**Addendum
Phase II Site Assessment and
Supplemental Soil-Gas Survey Workplan
Utility Trailer Manufacturing Company
City of Industry, California**

SITE PLAN
Utility Trailer Manufacturing Company
City of Industry, California

Mr. Robert Griffis
Utility Trailer Manufacturing Co.
17300 E. Chestnut Street, P.O. Box 1299
Industry, CA 91749-1299REVIEW OF REVISED ADDENDUM TO PHASE II SITE ASSESSMENT WORK PLAN
(FILE NO. 105.0296)

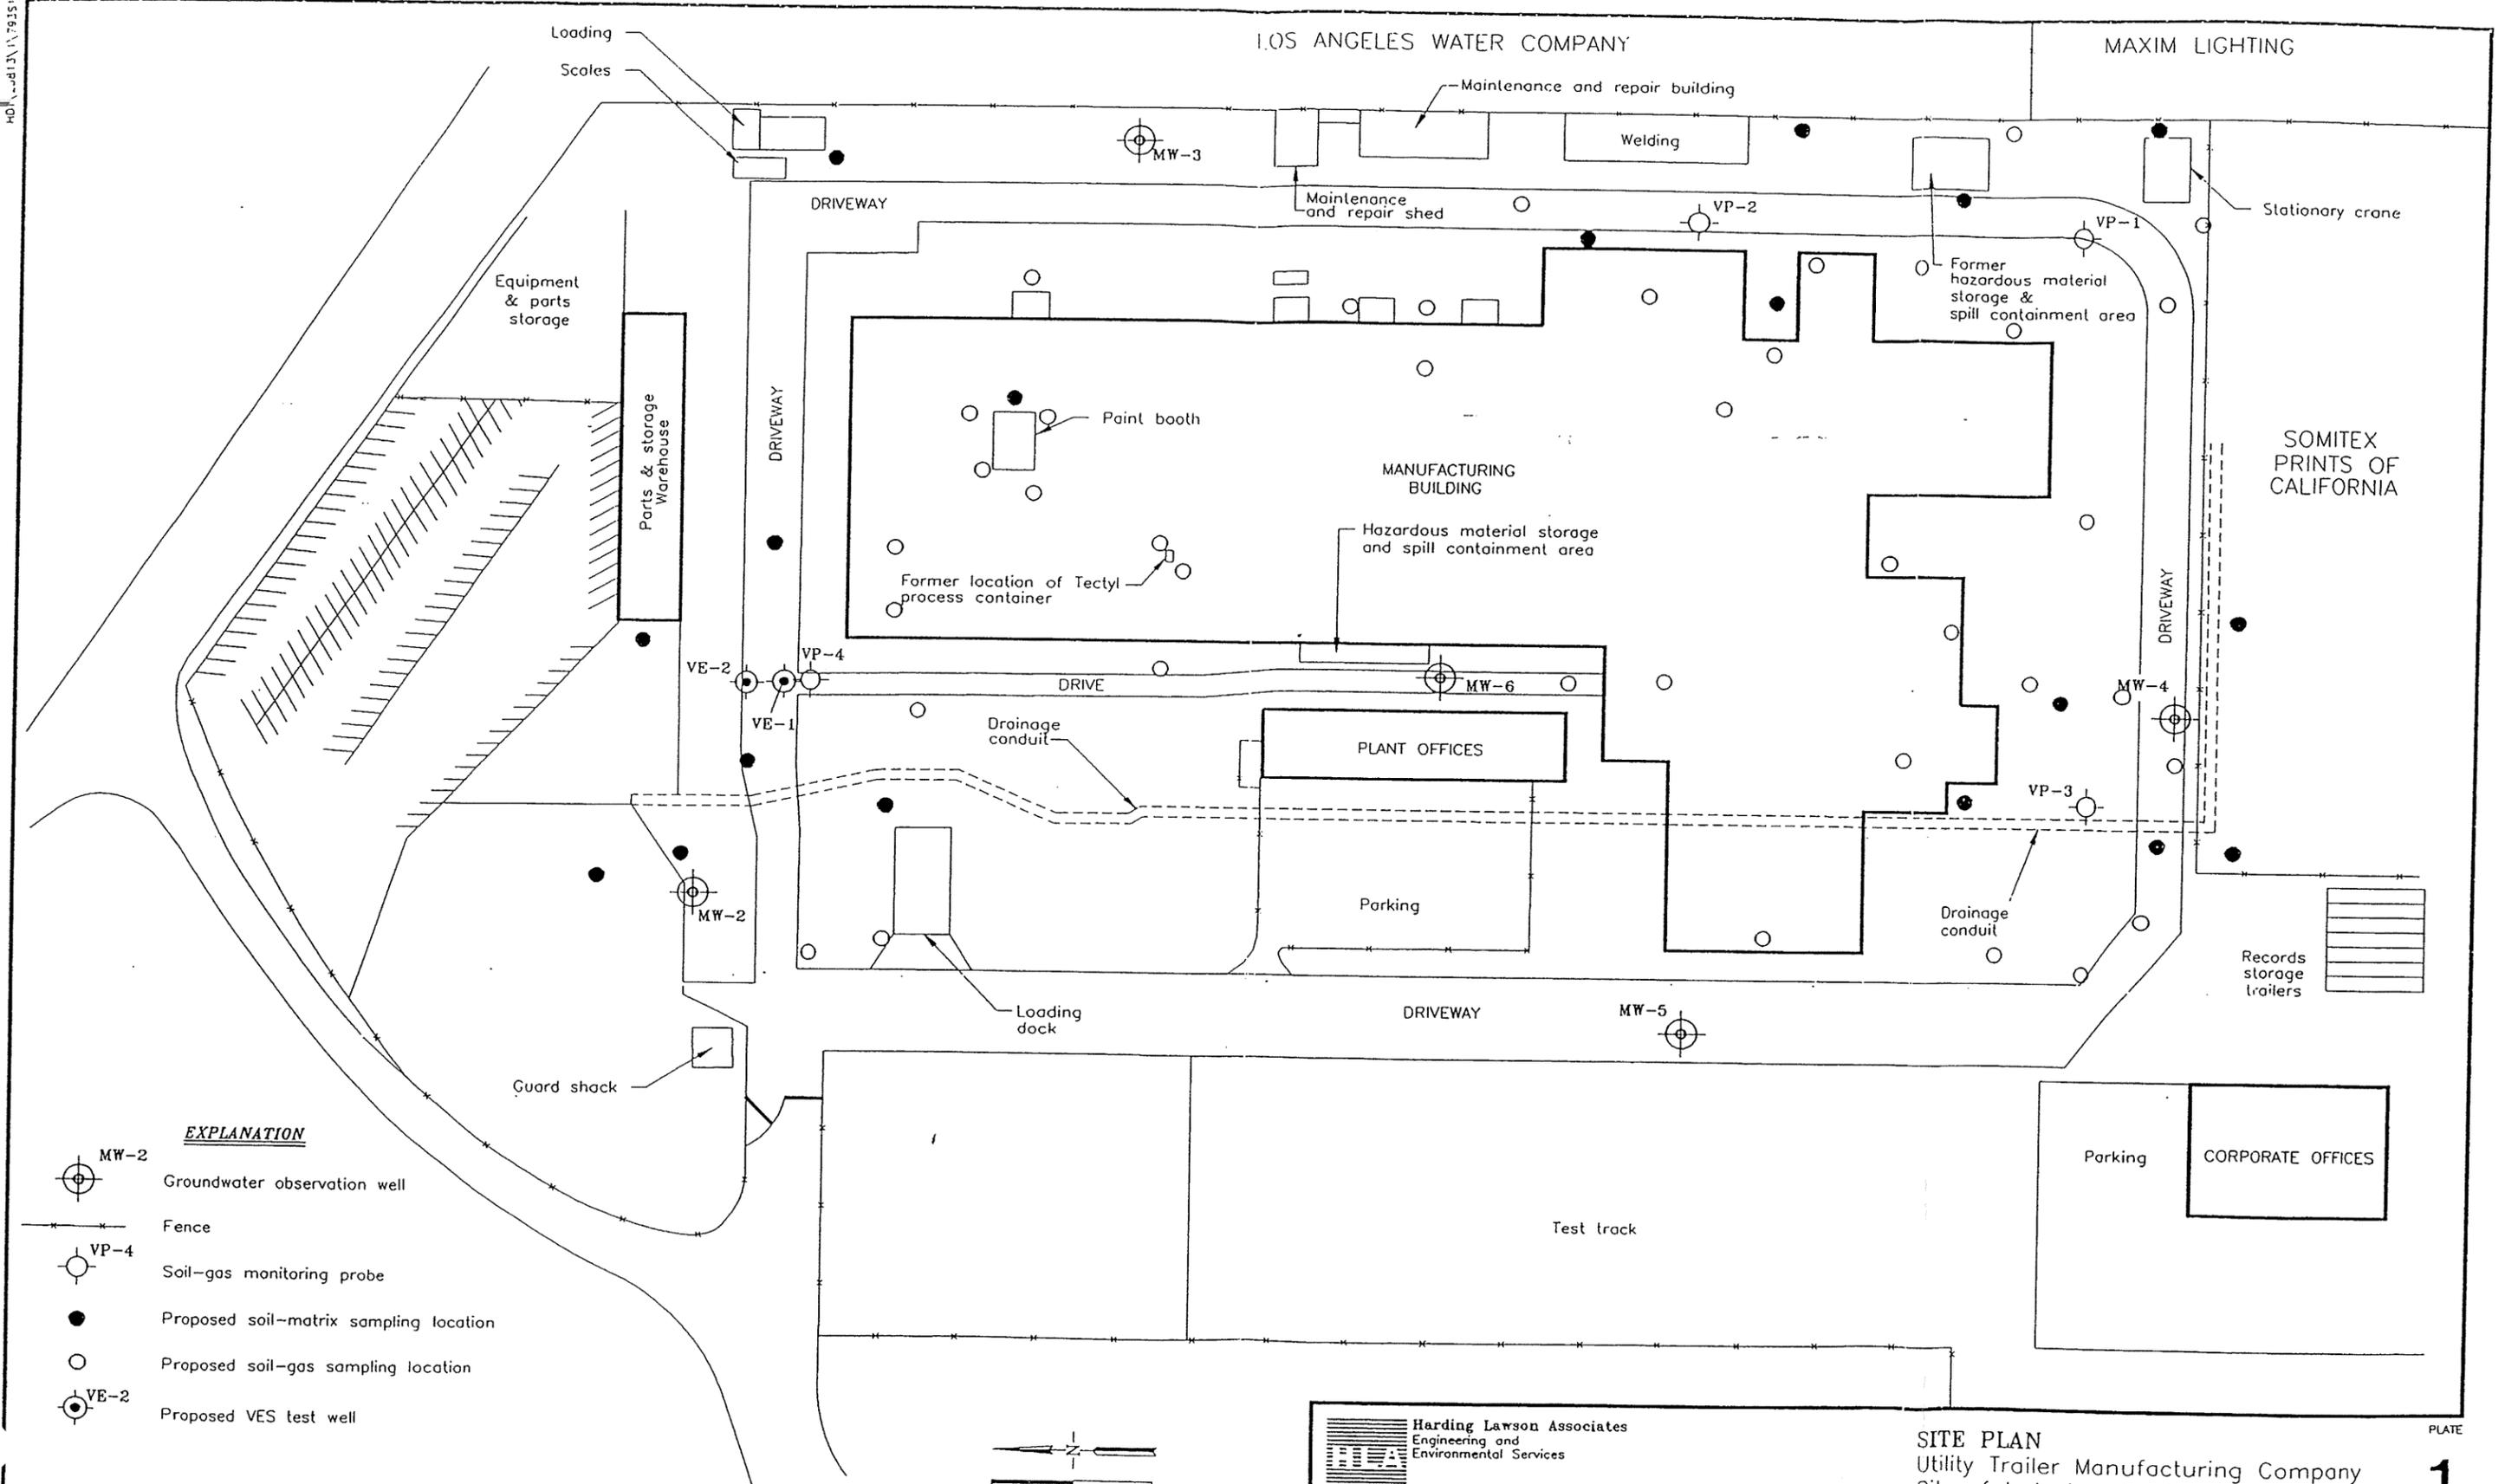
Plate 1 presents the soil-gas sampling locations for the proposed supplemental soil-gas investigation. In summary, a total of 9 locations have been added to the 30 proposed in the addendum dated April 15, 1993 (29 locations were erroneously identified in the text of the addendum).

As requested in your letter, we have moved the location of the proposed boring at the paint booth in the northern portion of the building closer to the former soil -gas probe. In addition, we are proposing 6 additional soil-matrix sampling locations. The rationale for these additional proposed locations are as follows:

- Of the two proposed locations at the northwestern end of the Somitex property, one will further delineate and quantify the elevated VOCs detected in the soil gas in that area and the second

will provide background information.

- The two locations proposed in the area surrounding MW-2 will further quantify data collected from borings drilled during the initial assessment work in that area.
- The two locations in the southeastern boundary of the site will further delineate and quantify the elevated VOCs detected in the soil-gas in that area.

All borings will be drilled with a truck or track-mounted auger drill rig equipped with 8 or 10-inch-outer diameter hollow-stem augers. Soil samples will be collected at 5-foot intervals with a Sprague and Henwood 2.4-inch-diameter sampler lined with brass tubes. Samples will be handled as described in the January 14, 1993 workplan. Plate 1 presents the proposed locations for the additional soil borings.

3. The revised addendum did not respond to the following:
 - i) Recommended use of soil vapor sampling probe with minimal dead volume.
 - ii) Two former paint booths west of the former TCA

still are still not adequately covered by the proposed additional soil vapor sampling probes.

PROJECT IMPLEMENTATION SCHEDULE
 Utility Trailer Manufacturing Company
 City of Industry, California

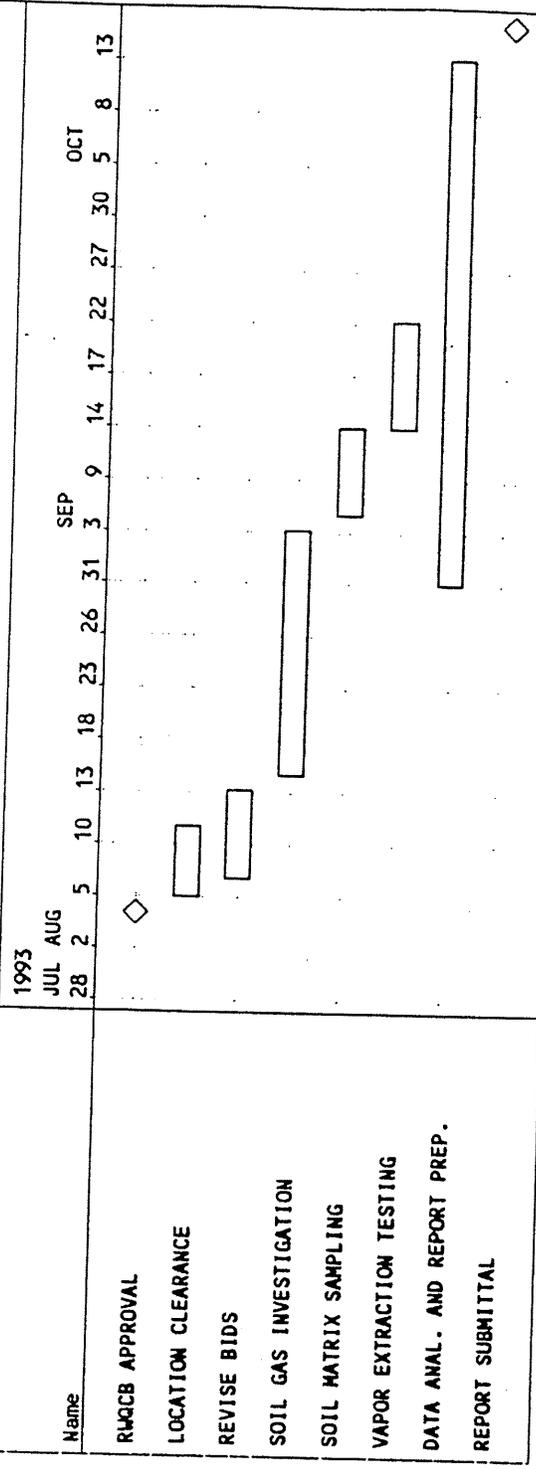
Field work can start within approximately one week following final approval of the RWQCB. Because more than 90 days had elapsed from when the original addendum was submitted, our subcontractors will need to submit revised bids which will take approximately 1 week. Soil-gas and soil-matrix sample location clearance is expected to take approximately 3 days. Concrete coring and the supplemental soil-gas survey is expected to take approximately 14 days. The soil-matrix sampling is expected to take approximately 5 days and will follow the soil-gas survey. Vapor extraction test well installation and vapor extraction testing are expected to take approximately 6 days. Data analysis and report preparation are expected to take approximately 6 weeks. Plate 2 presents the anticipated schedule. We request that the report submittal deadline be changed to October 15, 1993.

The work plan as amended by the two addenda is now conditionally approved provided a short letter responding to Item 3 above is provided to this office before commencement of the additional soil gas investigation. Three copies of a report are due to this Regional Board by October 15, 1993.
